Copper Moon Tucson, Arizona

Pulte Homes

Enclosed are the results of our analysis of the plans submitted for Building America review at the Sonoran Moon and Sonoran Vista developments. This work includes calculation of design loads, Energy Star scores, energy guarantee figures, and testing goals.

Discussion of ventilation systems for Pulte-Tucson homes

Figure 1 Central-fan-integrated supply ventilation; outside air duct into ceiling return box

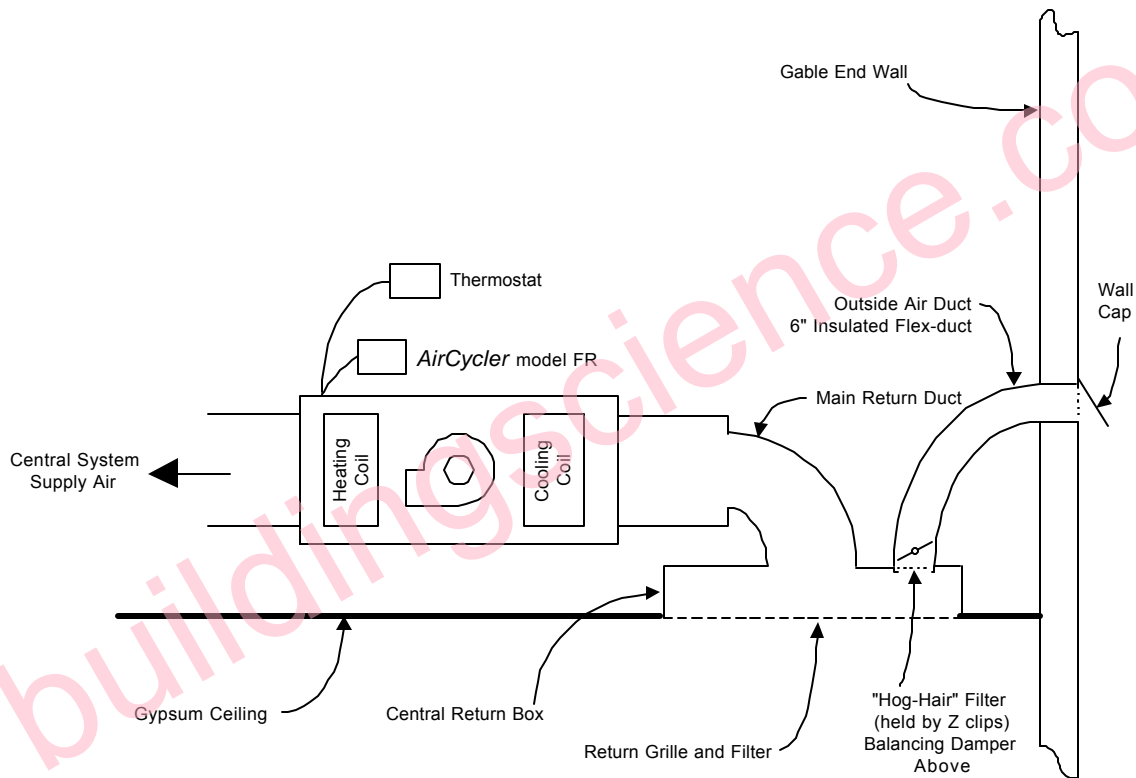
According to reports from the field (Bill Irvine and Len Utt), the outside air duct pressures were usually between -5 and -10 Pa with respect to outside, giving at least one-third less outside air flow than required. The low outside air duct pressure was likely due to how the duct was connected to the air handler return system. The system was specified to have a single ceiling return filter grille box with the outside air duct connected to the box, with a washable hog-hair-type filter held in place by a Z channel. Refer to Figure 1.

It appears that, in some cases, up to three return grilles were being installed. This leaves less flow, and hence, less available negative pressure available at the main return grille where the outside air duct is connected. Further, the return grille should be sized for 350 ft/min. Sizing the return for more than 350 ft/min could lead to noise problems, and sizing for less reduces the available negative pressure to draw in outside air.

Figure 2 Central-fan-integrated supply ventilation; outside air duct into extended collar

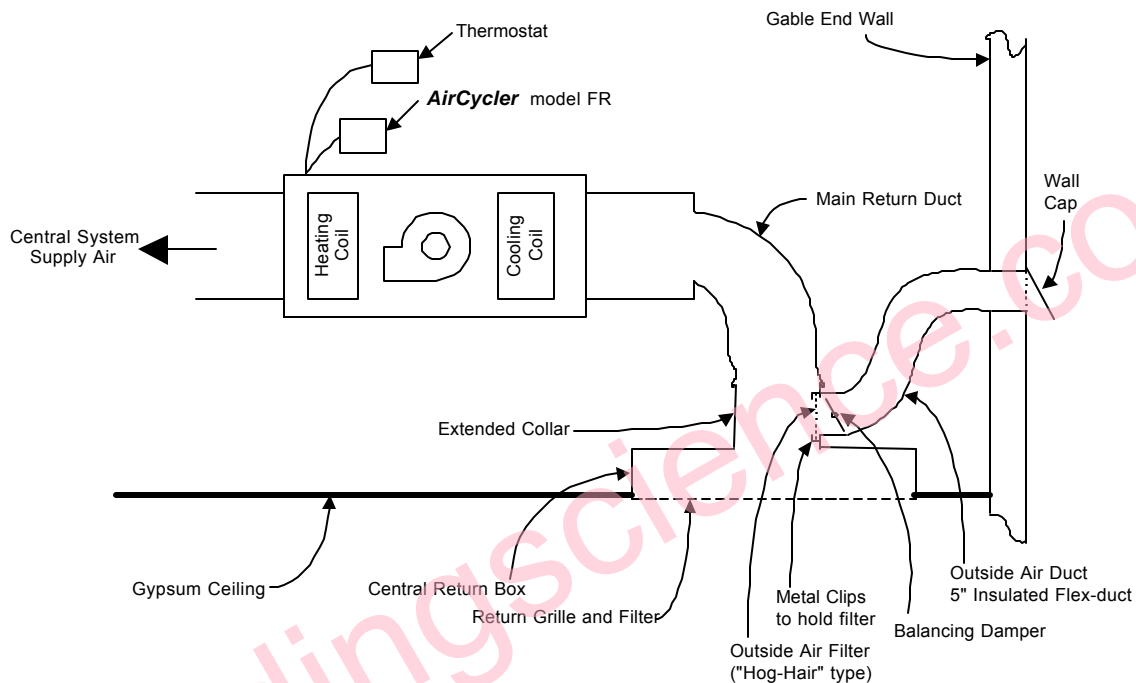
An alternative connection point that would always assure enough draw for outside air would be to connect the outside air duct to an extended collar where the main return flex duct connects to the return box. Refer to Figure 2.
